# River Medway (Flood Relief) Act 1976

## Inquiry into the Environment Agency's revised Scheme for the Leigh Flood Storage Area, Kent

### Statement of Case

### Appendix 3 – Environment Agency responses to Objections

Figure 7: Water levels at Penshurst gauging station 12 to 18 February 2020. Image from Shoothill Gauge map using data from Environment Agency gauging station

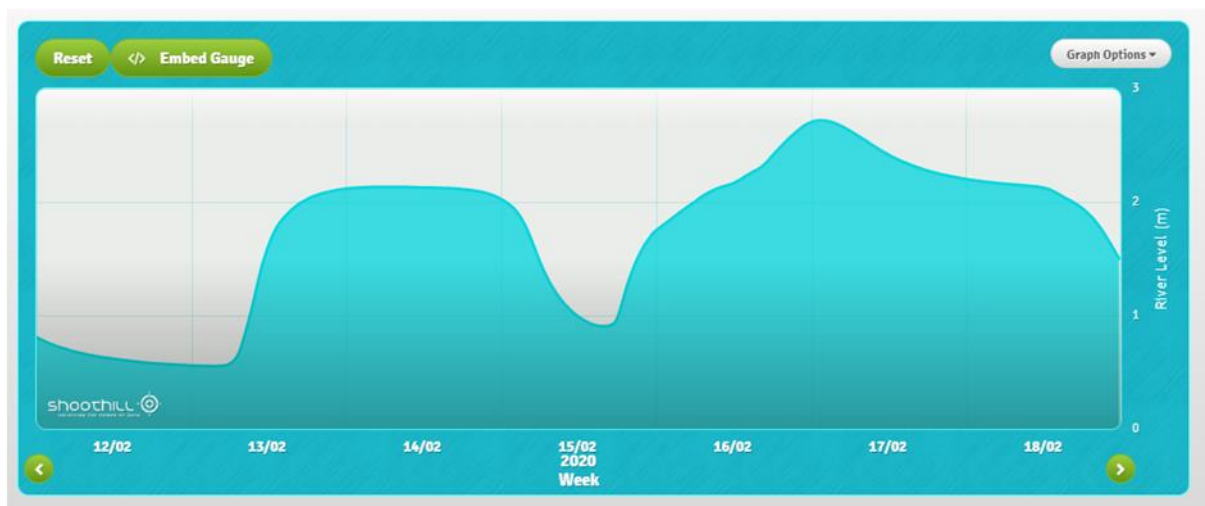
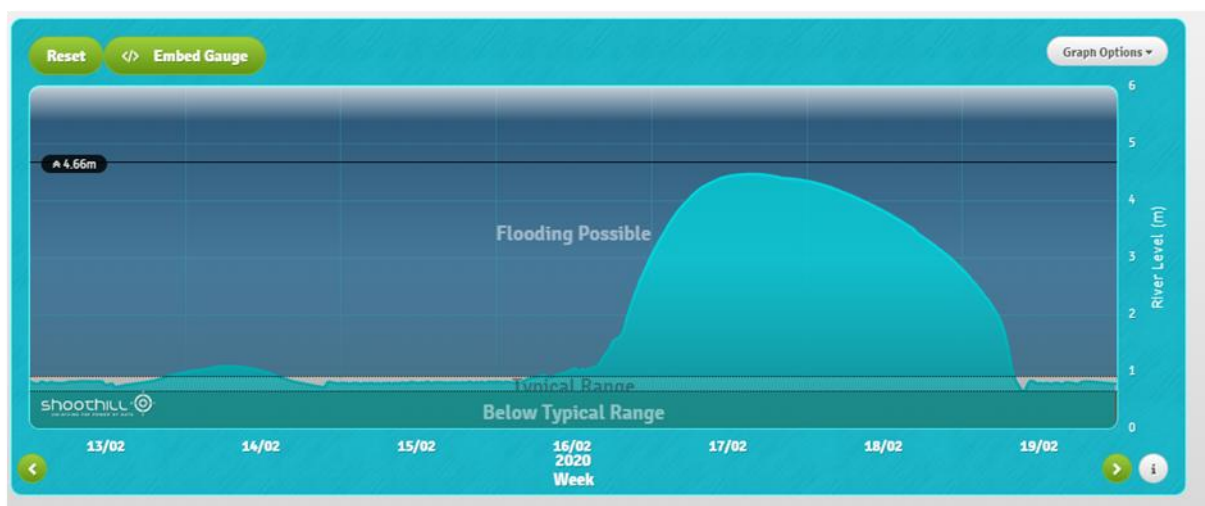
In your representation you suggest that Rogues Hill floods to up to 1m deep as a result of the operation of the FSA. Whilst in certain circumstances the FSA can, when operating, add up to 0.1m to the depth of water at Rogues Hill, the depth and timing of the flooding of Rogues Hill is dictated by upstream flows.

This is shown by the photographs provided in response to 3.1. To further illustrate this, the peak of the most recent flood at Penshurst Gauging Station was at 01:30 on 17 February 2020 (see Figure 7 below) and the water level was falling before the water levels at the Leigh FSA were rising as water was stored (see Figure 8). Penshurst Gauging Station is situated on the River Eden about 2.8 km upstream of Rogues Hill, and so the peak of this flood will occur earlier at Penshurst Gauging Station than at Rogues Hill but it clearly demonstrates that the water level in the river is independent of the operation of the FSA.

Figure 5: Increase in flood depth in a 1.33% flood event. 28.05m AOD vs 28.6m AOD

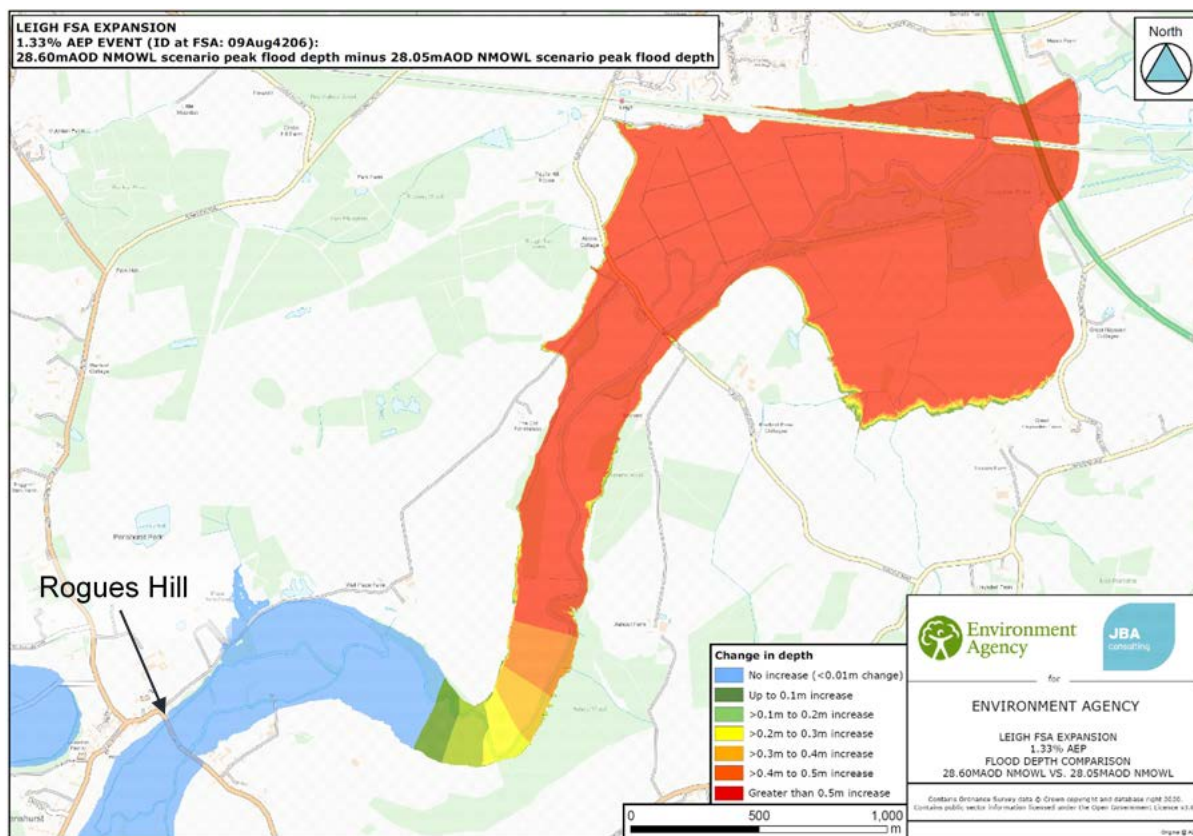
Whilst, as explained in our response to point 1, operation of the existing FSA can in certain circumstances make the flood water up to an extra 0.1m deeper at Penshurst, our modelling indicates that the proposed change to increase the maximum impoundment level will not increase the depth of flooding above Rogues Hill any further. This is demonstrated in Figure 5 below. Figure 5 shows the increase in flooding depth from raising the Leigh FSA maximum impoundment level from 28.05m Above Ordnance Datum (AOD) to 28.6m AOD (measured at the main Leigh FSA embankment) during a 1.33% flood event. The map below has been taken from the Flood Risk Assessment for consistency. This map has been updated since the

submission of the Application. Whilst it shows greater depth variation lower in the FSA, the point at which the effect of the expansion dissipates remains the same.

Every flood event is different, depending on a number of factors, including soil saturation and weather patterns. The modelled scenario in Figure 5 was chosen to demonstrate the impact of expanding the FSA because it shows the greatest change in flood depths.

*Figure 6: Flooding of Rogues Hill in 1937*

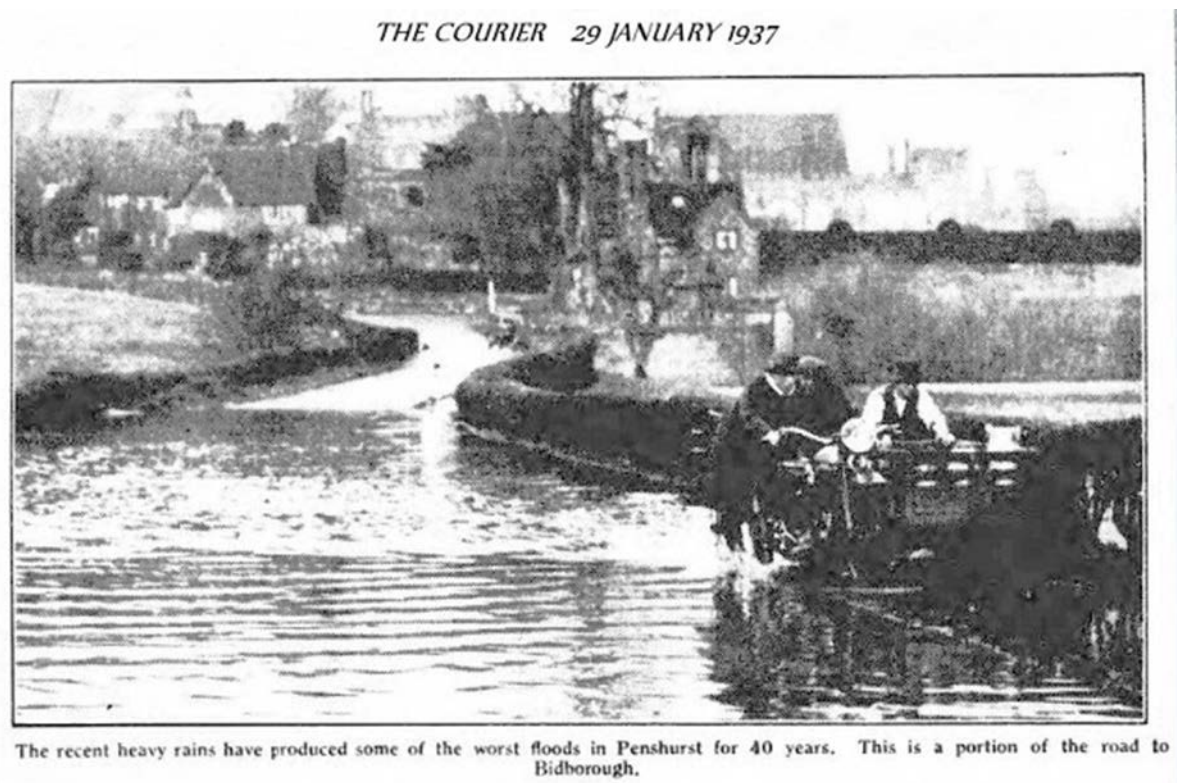
In your representation you suggest that Rogues Hill floods to up to 1m deep as a result of the operation of the FSA. Whilst in certain circumstances the FSA can, when operating, add up to 0.1m to the depth of water at Rogues Hill, the depth and timing of the flooding of Rogues Hill is dictated by upstream flows. This is shown by the photographs provided in response to point 1.

The photograph below from a 1937 newspaper article (Figure 6) shows flooding on Rogues Hill. In 1968 the flooding at this location was so severe that the Rogues Hill road bridge over the River Medway was damaged to such an extent a temporary bridge had to be installed. These events show that Rogues Hill has historically experienced flooding and that it is not the operation of the Leigh FSA that causes flooding.

Figure 1: Increase in flood depth in a 1.33% flood event. 28.05m AOD vs 28.6m AOD

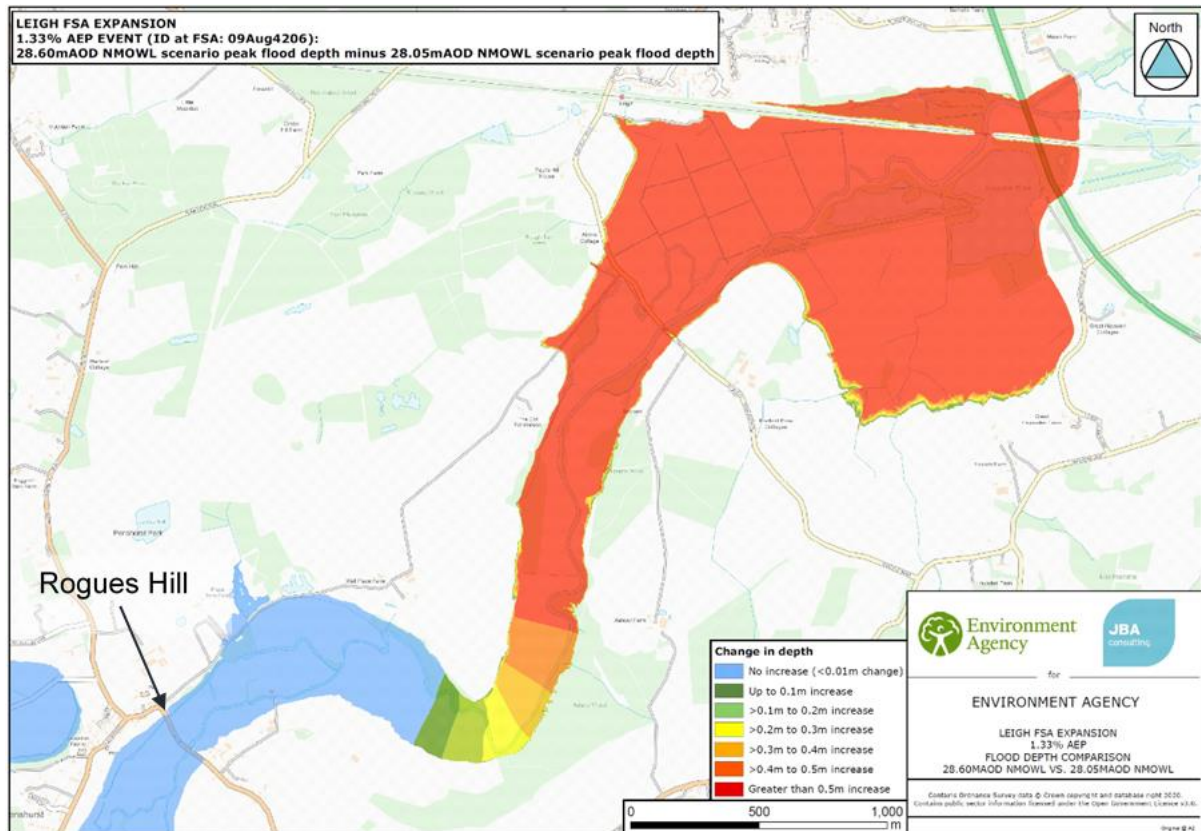
Safety is always of paramount importance to us and a key consideration for all of our work.

Our modelling indicates that the proposal to increase the maximum impoundment level will not increase the depth of flooding above Rogues Hill. This is demonstrated in Figure 1 below. Figure 1 shows the increase in flooding depth from raising the Leigh FSA maximum impoundment level from 28.05m Above Ordnance Datum (AOD) to 28.6m AOD (measured at the main Leigh FSA embankment) during a 1.33% flood event. For consistency, the map below has been taken from the Flood Risk Assessment which accompanies the planning application. This map has been updated since the submission of the Application. Whilst it shows greater depth variation lower in the FSA, the point at which the effect of the expansion dissipates remains the same.

Every flood event is different, depending on a number of factors, including soil saturation and weather patterns. The modelled scenario in Figure 1 was chosen to demonstrate the impact of expanding the FSA because it shows the greatest change in flood depths.

*Figure 2: Flooding of Rogues Hill in 1937*

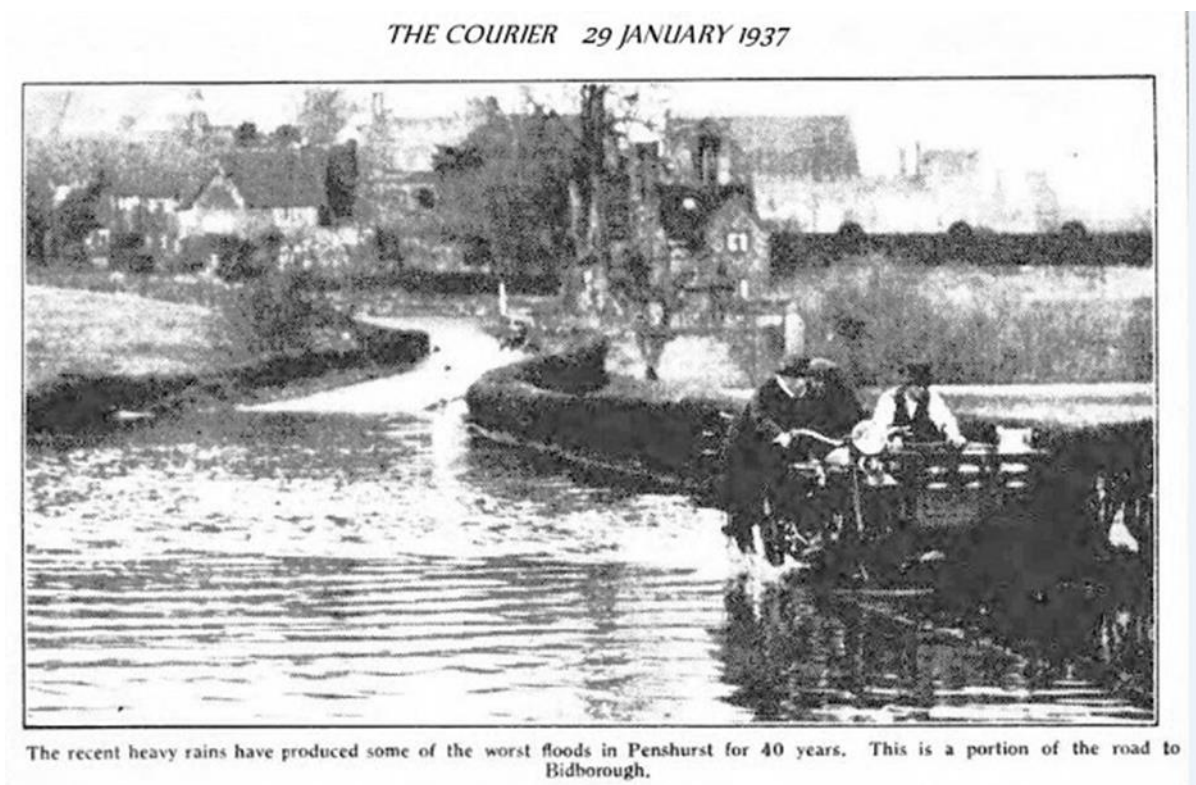
We acknowledge that areas of Penshurst can be affected by the operation of the existing Leigh FSA, depending on the size of the flood event.

However, there are historical reports of flooding in Penshurst which occurred prior to the construction of the FSA, demonstrating that the area is affected by natural flooding. Indeed, the FSA itself was constructed in response to the 1968 flood when the flooding at Rogues Hill was so severe that the road bridge over the River Medway was damaged and a temporary bridge had to be installed. The photograph below from a newspaper article (Figure 2) shows flooding on Rogues Hill in 1937. These events demonstrate that Rogues Hill was vulnerable to flooding prior to the construction of the FSA.

*Figure 1: Flooding of Rogues Hill in 1937*

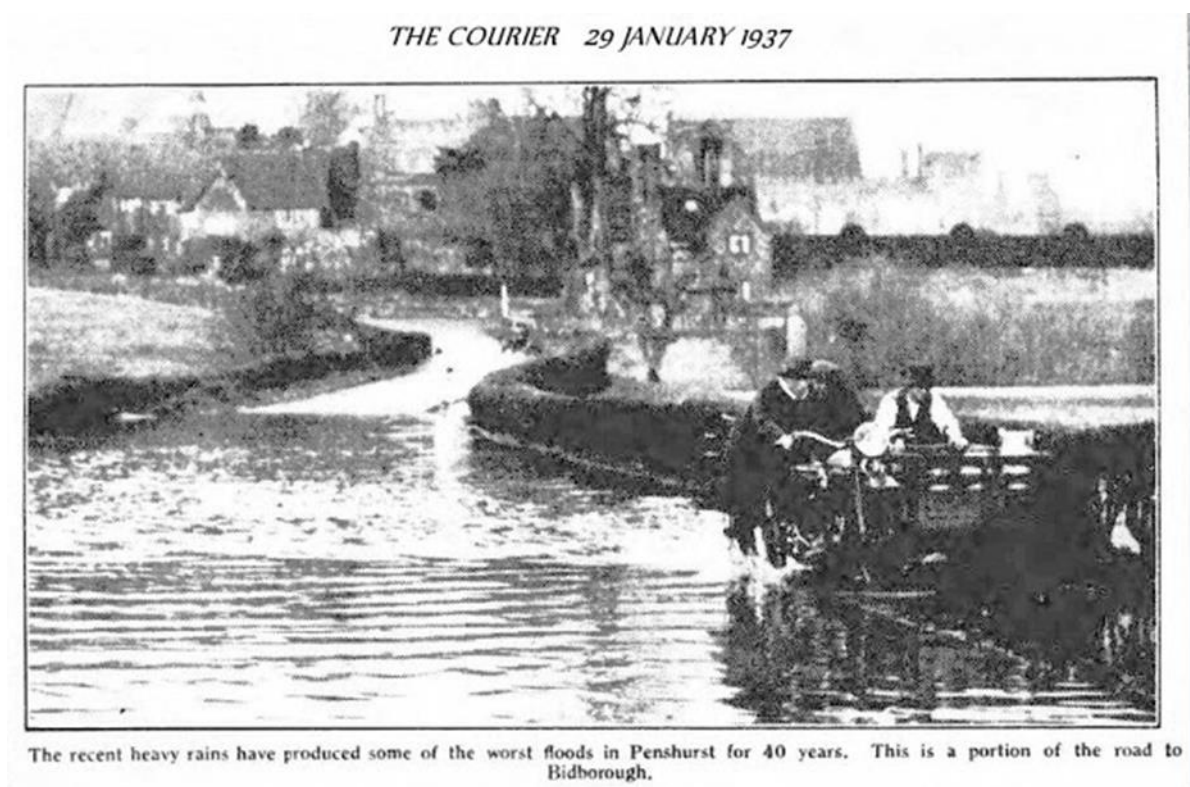
Environment Agency response to point 1:

The land adjacent to the Rogues Hill causeway is particularly vulnerable to flooding. The photograph below from a 1937 newspaper article (Figure 1) shows flooding on Rogues Hill. In 1968 the flooding at this location was so severe that the road bridge over the River Medway was damaged and a temporary bridge had to be installed. These events demonstrate that Rogues Hill was vulnerable to flooding prior to the construction of the Leigh Flood Storage Area (FSA).

Figure 1: Extent of your property (Longford) that might be affected in a 1% AEP + 20% flood event.

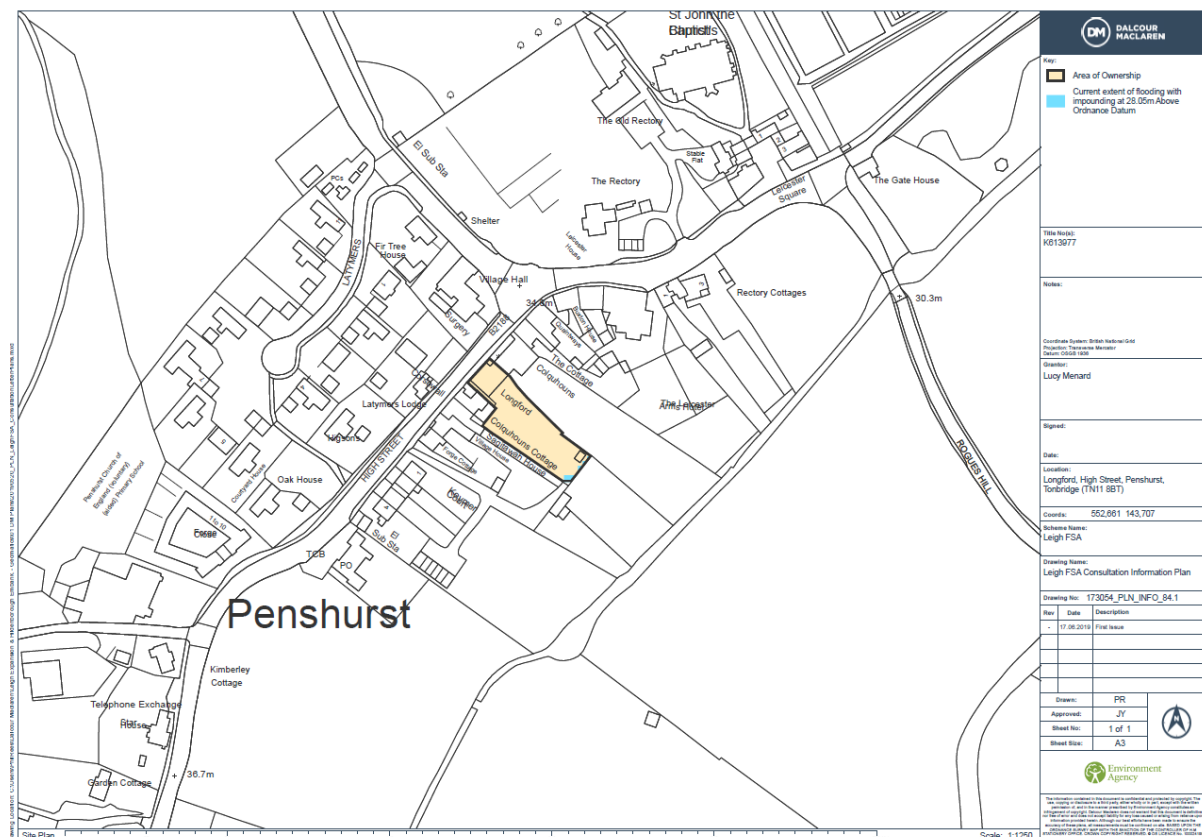
Environment Agency response to point 1:

Longford is on the very edge of the land that might be flooded. The plan below (Figure 1) shows the extent of your property shaded. In the southern part of your property is a small area shaded blue. This is the land that might currently be flooded by a 1% AEP + 20% flood event. You will note that your garage, which is situated on raised land, is not affected.

*Figure 7: Flooding of Rogues Hill in 1937*

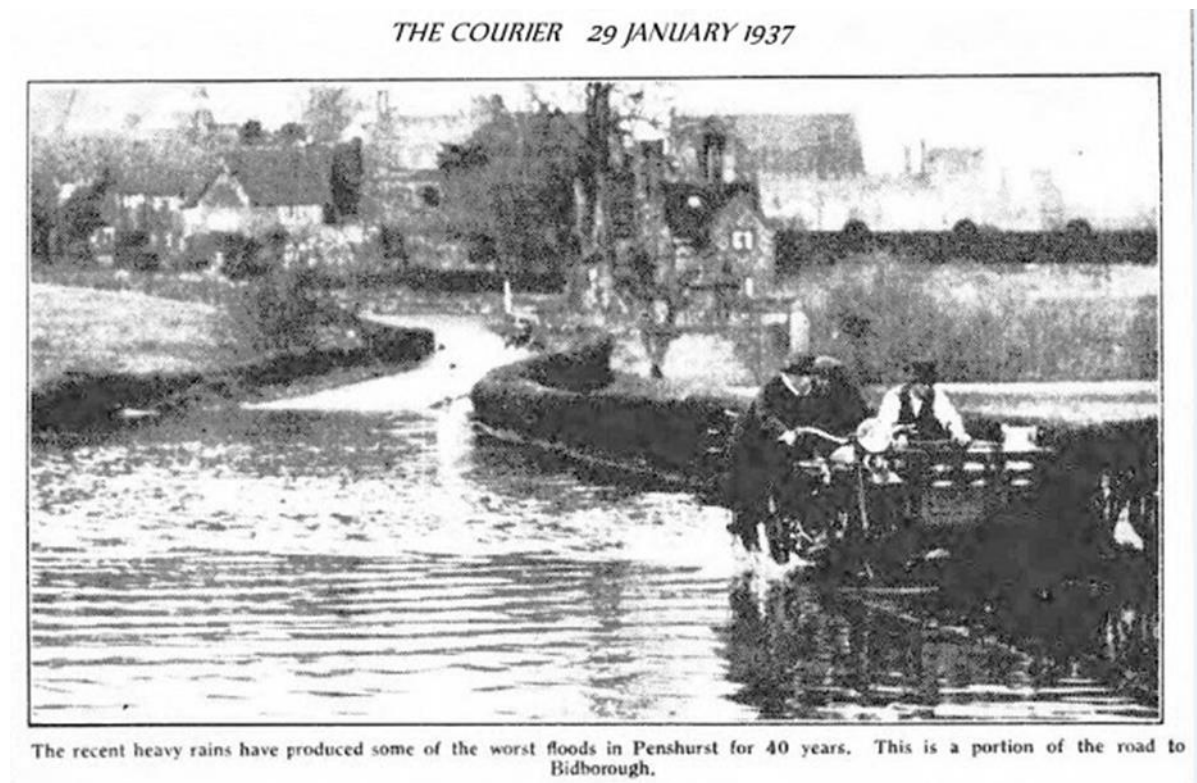
In your representation you suggest that Rogues Hill floods to up to 1m deep as a result of the operation of the FSA. Whilst in certain circumstances the FSA can, when operating, add up to 0.1m to the depth of water at Rogues Hill, the depth and timing of the flooding of Rogues Hill is dictated by upstream flows. This is shown by the photographs provided in response to 5.

The photograph below from a 1937 newspaper article (Figure 7) shows flooding on Rogues Hill. In 1968 the flooding at this location was so severe that the Rogues Hill road bridge over the River Medway was damaged to such an extent a temporary bridge had to be installed. These events show that Rogues Hill has historically experienced flooding and that it is not the operation of the Leigh FSA that causes flooding.
